SUBJECT: REQUEST FOR ADDITIONAL INFORMATION REGARDING APPROVAL TO
STORE SPENT NUCLEAR FUEL IN THE ADVANCED NUHOMS® STORAGE
SYSTEM (TAC NO. L23203)

**TRANSNUCLEAR WEST INC.
DOCKET NO. 72-1029
TAC NO. L23203**

REQUEST FOR ADDITIONAL INFORMATION

Figure 1

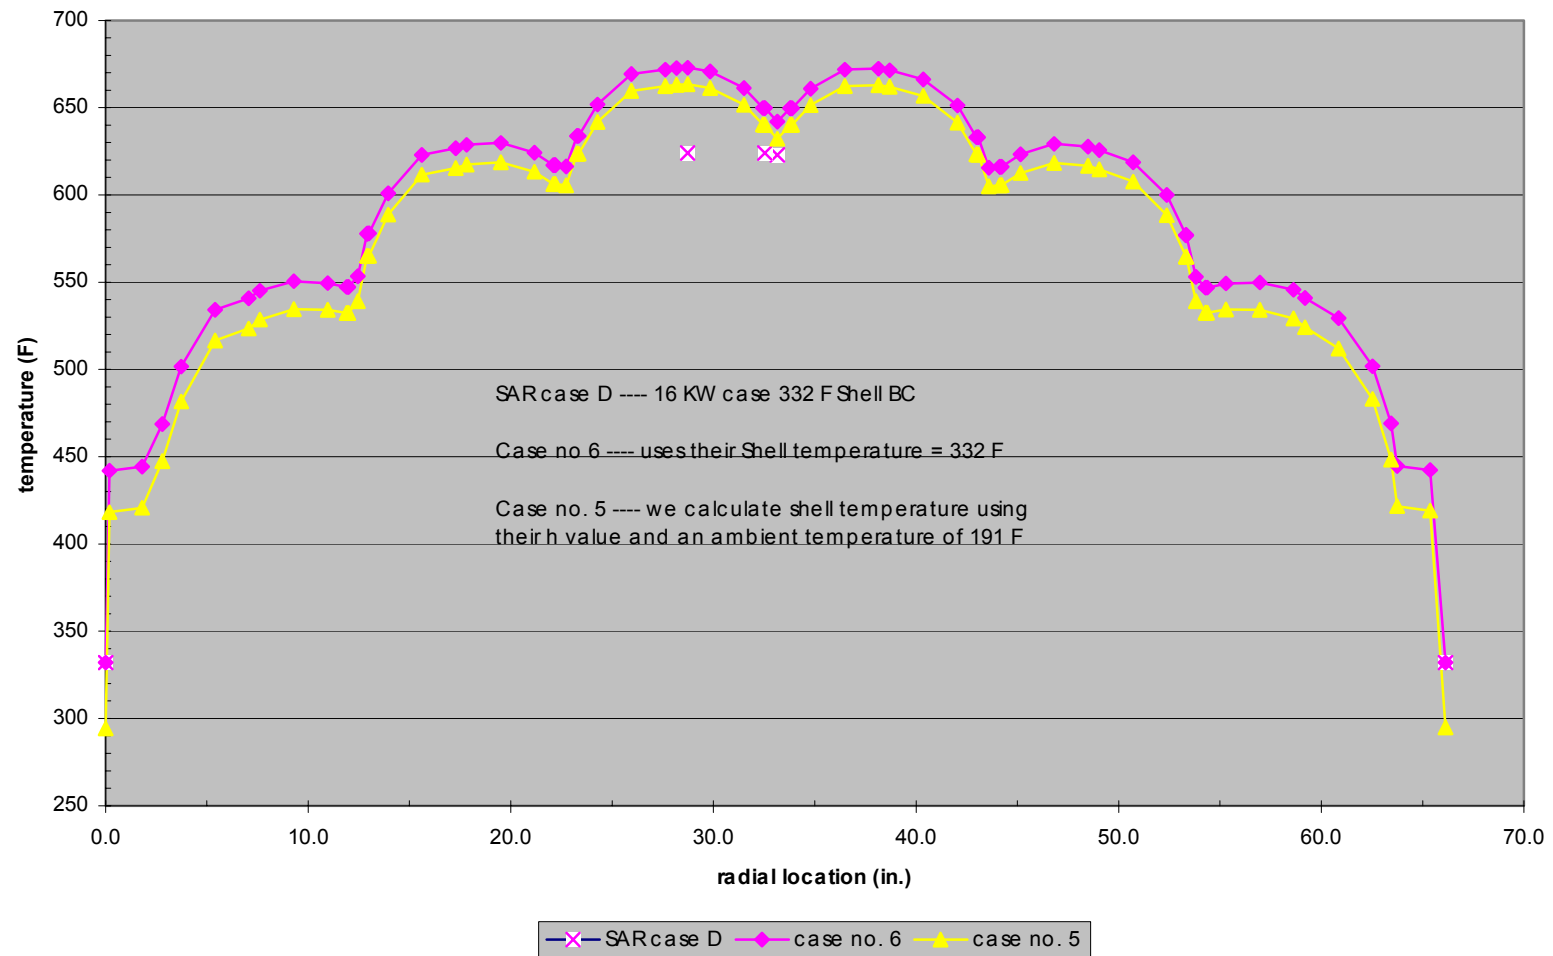
The staff's independent analysis did not confirm the thermal performance of the Standardized Advanced NUHOMS System as described in Section 4 of the safety analysis report (SAR). The staff found that long term fuel cladding temperature limits may be exceeded during normal conditions of storage. Specifically, Table 1 provides the results of the staff's analysis which indicate that the peak cladding temperatures, under normal conditions, exceed those provided in Table 4.1-3 of the SAR. The independent analysis was performed using nominal gap dimensions and material properties for the 24PT1 dry shielded canister (DSC) as provided in the SAR. The staff performed the analysis using a heat load of 16 kW to match that used by the applicant in its analysis. Figure 1 provides the temperature profile for the 24PT1 DSC as determined by the independent analysis.

- 4-1. Provide a radial temperature profile through the container for the normal storage condition case at 14 kW or a higher heat load that bounds 14 kW.

Include all temperatures of all components along the radial line, including inner and outer DSC shell, guidesleeve, boral plate, and oversleeve, as well as temperatures in the spacer disc and multiple fuel cladding temperatures across each fuel assembly traversed by the radial line. The fuel cladding temperatures in the plot should include the peak cladding temperature in each fuel assembly in the plot. The staff requires this information to assess compliance with 10 CFR 72.122(h)(1).

- 4-2. Provide the values specified for the width of the gap between the spacer disc and the DSC shell, and all other gaps in the HEATING7 model used to determine the DSC radial temperature profile requested in Question 4-1 above.

This should include a justification for the gaps used in the HEATING7 thermal model based on using the most conservative design basis tolerances. The staff requires this information to assess compliance with 10 CFR 72.122(h)(1).

- 4-3. Provide an explanation of how thermal expansion of the materials were taken into account and how the gaps in the model were determined.

The explanation should include: 1) whether the gaps differ from the values reported on the drawings included in the SAR; and 2) a justification of the thermal expansion values for each of the materials involved in the analysis. The staff requires this information to assess compliance with 10 CFR 72.122(h)(1).
